MEMORANDUM

REVIEW TYPE: Preliminary Plan Review

PROJECT NAME: Bank of America - Woodmoor

CASE #: 120060460 (Formerly 1-06046)

EXHIBIT 8
 RECOMMENDED
 FUTURE LANE USE

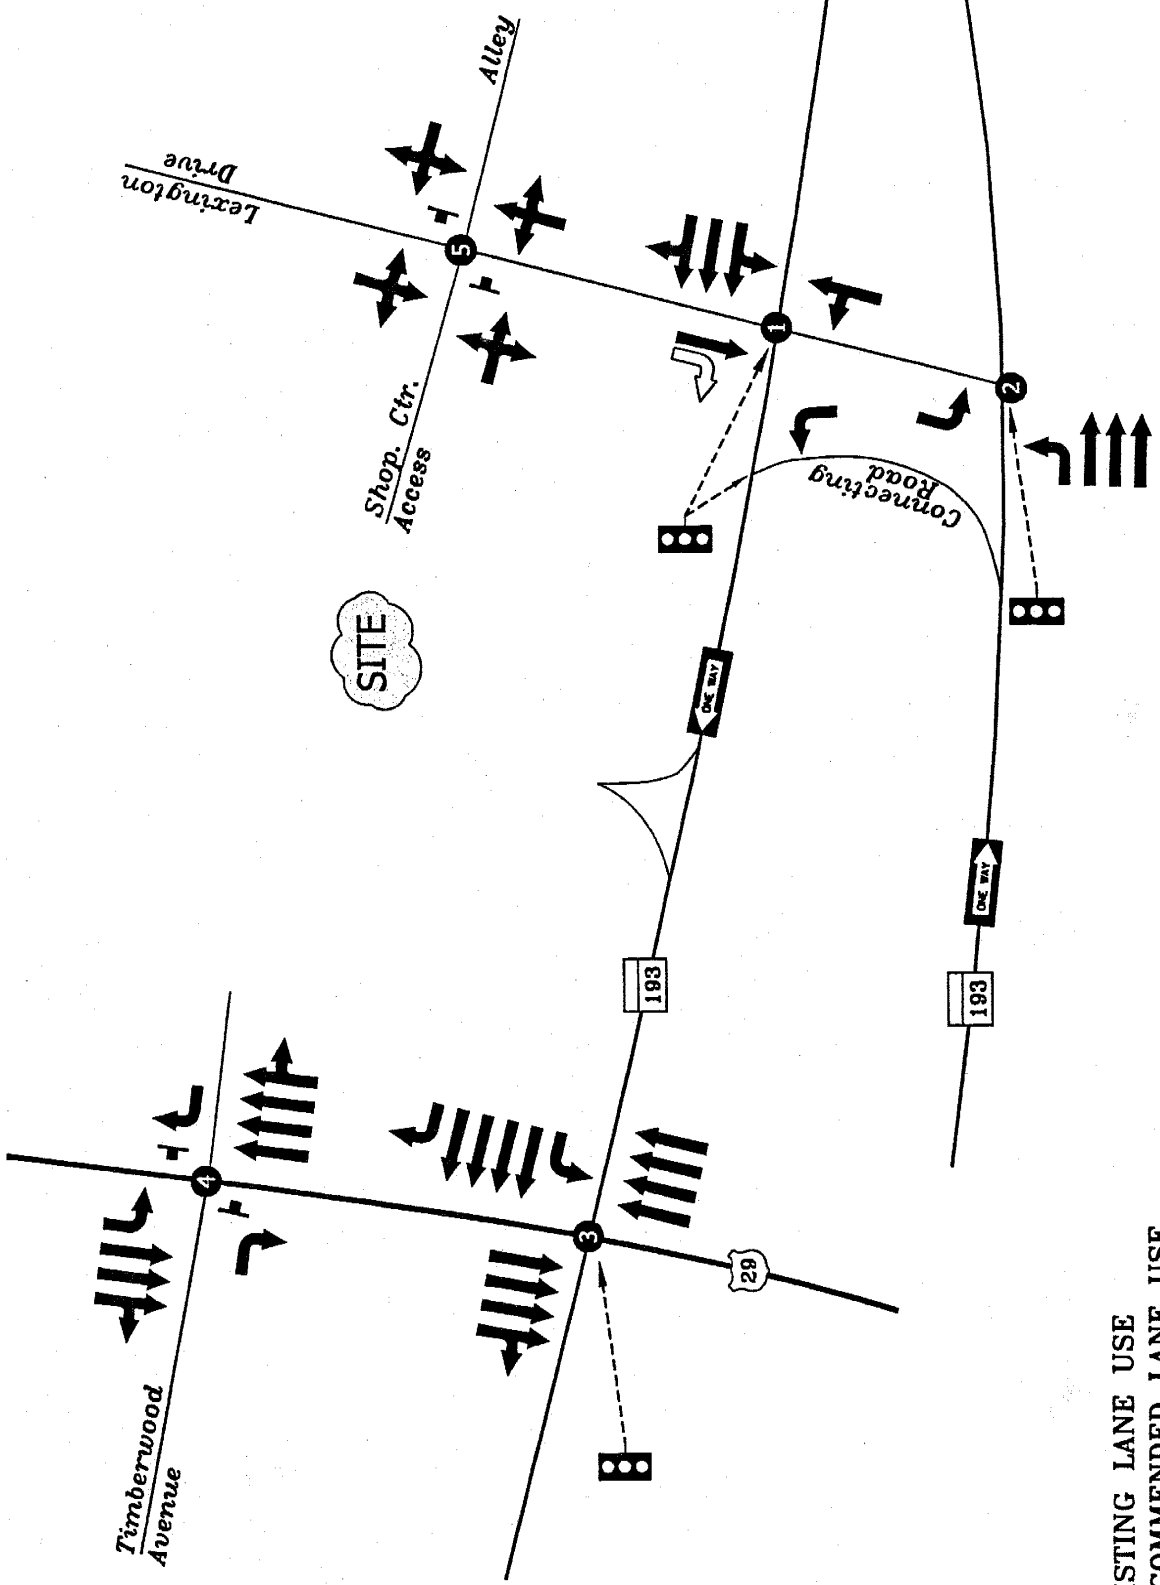
One of the LATR requirements is to construct a separate right-turn lane from the site access point to University Boulevard along Lexington Drive. This additional capacity at the intersection will greatly relieve the existing situation by doubling storage capacity.
